RE: TEDS Exception No. 30-03, for Access Spacing at 588 North Commercial Drive

DESIGN EXCEPTION #DE30-03

RE: Exception for Access Spacing at 588 North Commercial Drive

**TEDS Exceptions Request
for
588 N. Commercial Drive**

SITE PLAN

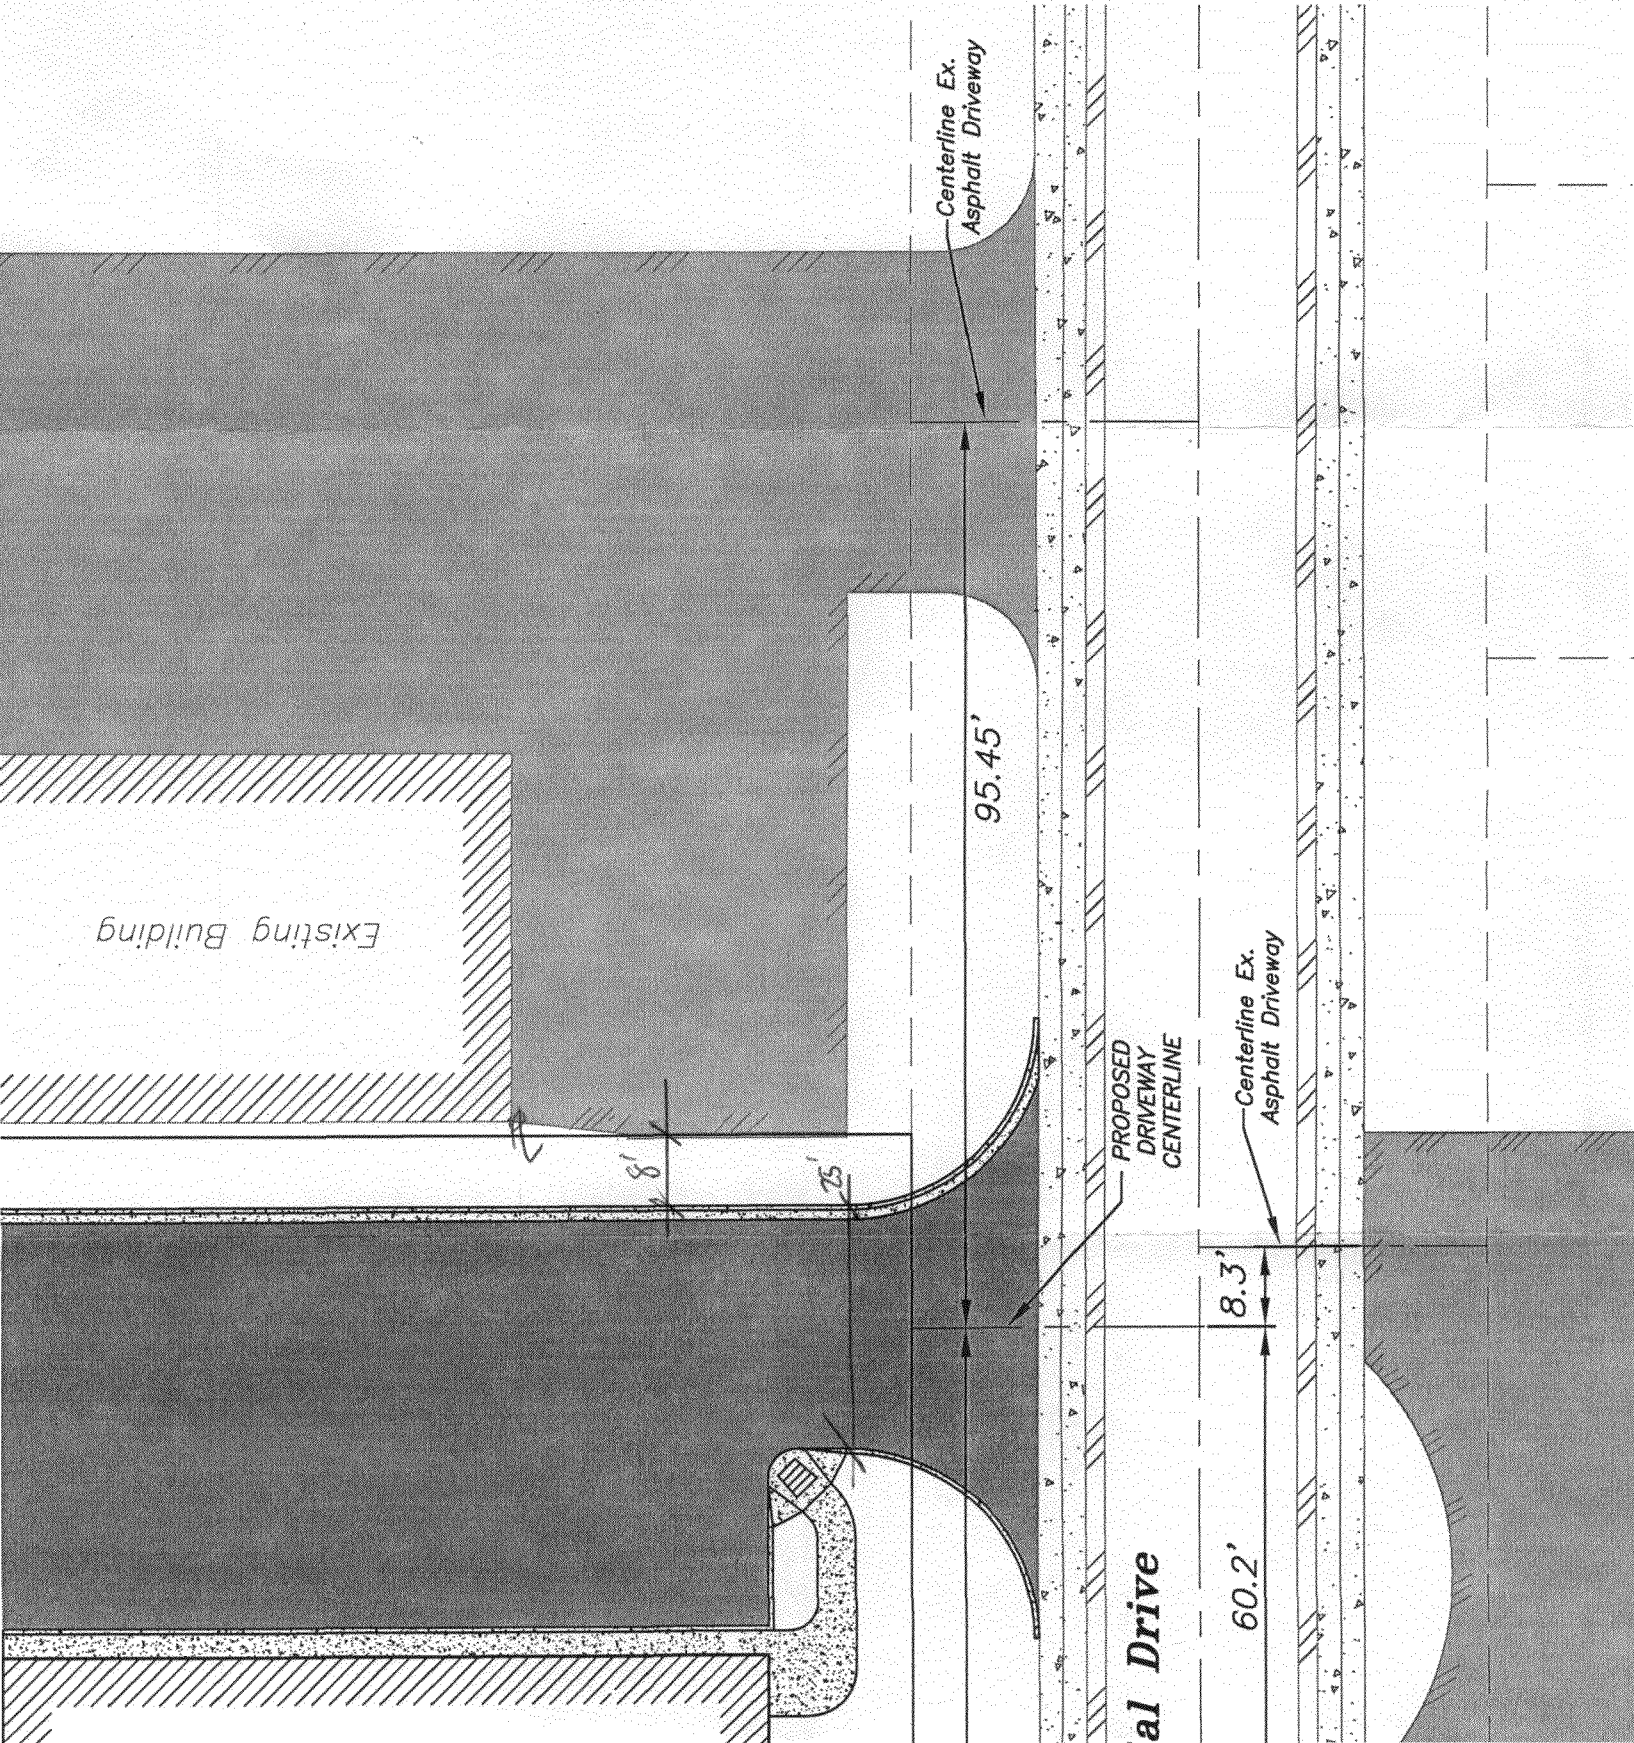
Physical restraints do not allow any access configuration along the south side of this site to align with the opposing access. Eight feet is not a serious deviation from our regulation and the offset is in the direction that will avoid conflicting left turns into the sites.

Exhibit 1 shows the proposed access location for the site. In addition, the accesses on the opposite side of the street along with those on the same side of the street are shown with key dimensions given. Following is discussion regarding each TEDS Manual requirement and justification for the access location as proposed.

Access Spacing - Due to the fact that the adjacent property accesses to the north and south are less than 300' apart, it simply is not possible to design the site access spacing to be at least 150' from each.

Access Offsets - In order to design the site access to align perfectly with the access on the opposite side of the street, the 5' spacing to the

property line required in TEDS 4.1.1 cannot be met and the south property line landscape buffer required in the Land Development Code cannot be met. Due to the fact that the accesses across the street are less than 300' apart, it is also not possible to design the site access to be 150' from each.

Attached please find a TEDS Exception for access spacing on N Commercial Drive. The southerly edge of the access is proposed at a point 8' north of property line. Access could be shifted 8' to the south to permit better, although not perfect, alignment with the opposing drive.

I recommend approval of the requested Design Exceptions to Sections 4.1.1, *Spacing*, and 4.1.2, *Offsets* to allow construction as proposed. It appears to be the option that most closely conforms to TEDS in light of the specific situation.

I have reviewed DE30-03 Exception for Access Spacing at 588 North Commercial Drive. I concur with Mike McDill's recommendation for approval since the spacing proposed will conform with the proposed modifications to TEDS and the off-set will not create safety problems. It appears the design proposed is the most reasonable given the existing lot configuration and adjacent building and driveway locations.
